AUDIT SUMMARY FOR THE REGULATORY AUDIT OF THE NUSCALE POWER, LLC, DESIGN CERTIFICATION APPLICATION, EMERGENCY CORE COOLING SYSTEM BORON REDISTRIBUTION ISSUE AND APPLICABLE DESIGN CHANGES

Convective Heat Transfer Mode

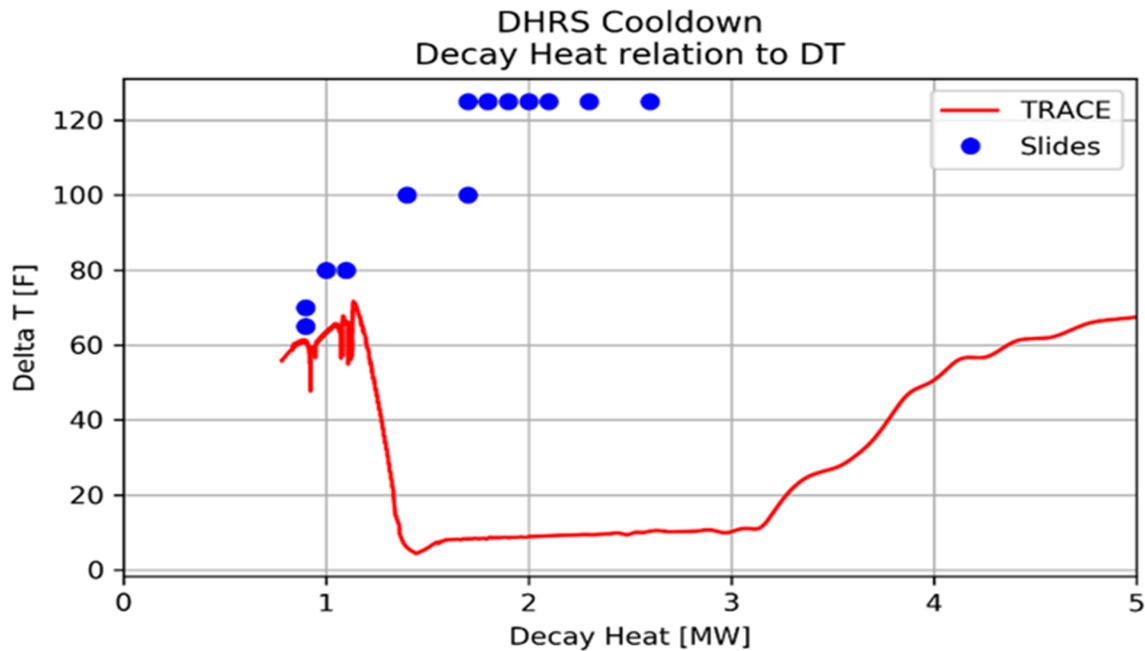
For the convective heat transfer mode, the NRC staff reviewed the applicant's calculation of the RCS condensation rate, through wall heat transfer, and riser-to-downcomer level difference at the time of uncover. The NRC staff found the applicant's calculation of condensation to be conservative, as the DHRS ability to remove heat (i.e., mass flow and temperature difference) was maximized. The DHRS heat removal capability was then converted into an RCS condensation rate independent of the exposed SG surface area. The NRC staff compared the applicant's hand-calculated condensation rate with the applicant's NRELAP5 values which were presented in Appendix F of EC-0000-7929 (see figure below). The NRC staff also compared the applicant's hand-calculated valves to the NRC staff's TRACE confirmatory code as shown below.
